**SUBJECT: AMENDMENT NO. 1 (Revised) - Otay Mesa Central Village Lumina Development On-Site Sewer Study (Tentative Map No. 1972222 | PTS No. 555609)**

**Amendment No. 1 Revised**

FIGURE 2

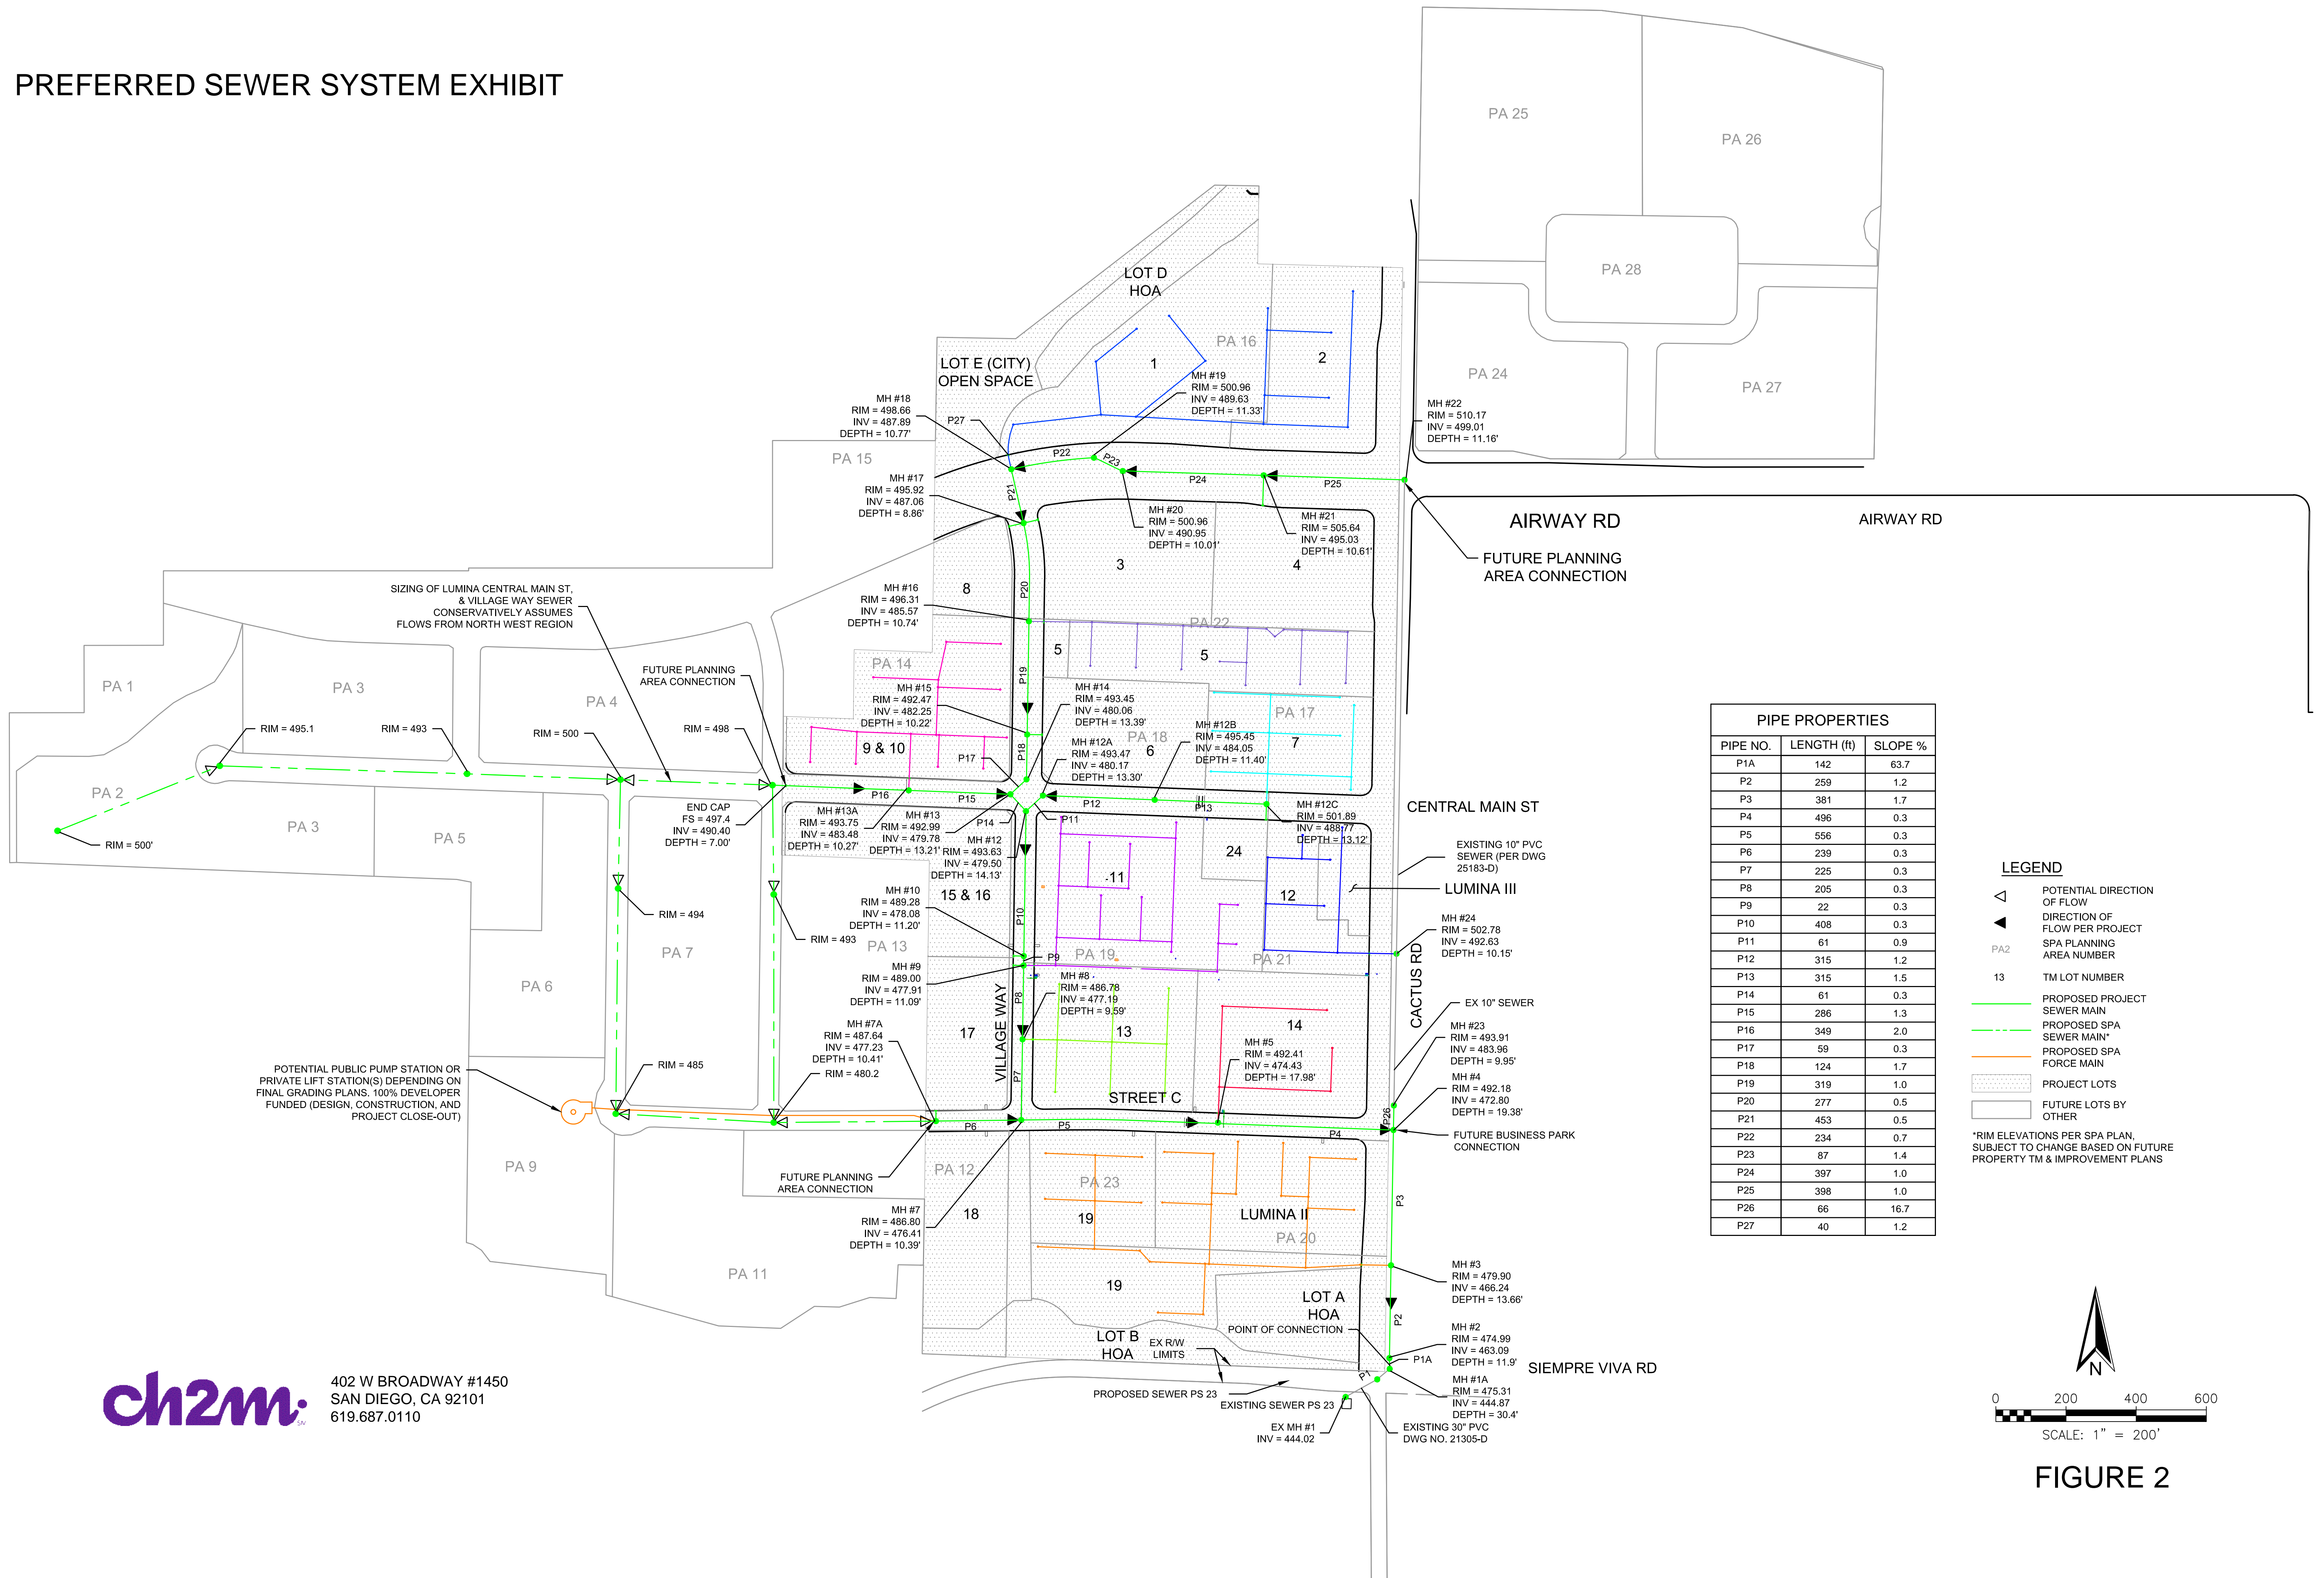
1. *The sewer exhibit should be size 24"x36" labeled all proposed developments.*
2. *On the sewer study exhibit, clearly show and label the proposed sewer laterals from the proposed developments to the point of connection to the existing public mains.*

1. The sewer exhibit should be size 24"x36" labeled all proposed developments.
2. On the sewer study exhibit, clearly show and label the proposed sewer laterals from the proposed developments to the point of connection to the existing public mains.
3. The sewer calculations table should be revised accordingly.

In response to this request Amendment No 1 Revised includes an updated sewer exhibit with all proposed developments labeled, and sewer lateral locations shown for each lot(s). The hydraulic calculations have been revised and reflect the final sewer design improvements being prepared by PDC. Based on the analysis, there were no changes to sewer pipe diameters and all City Sewer Design Criteria continues to be satisfied.
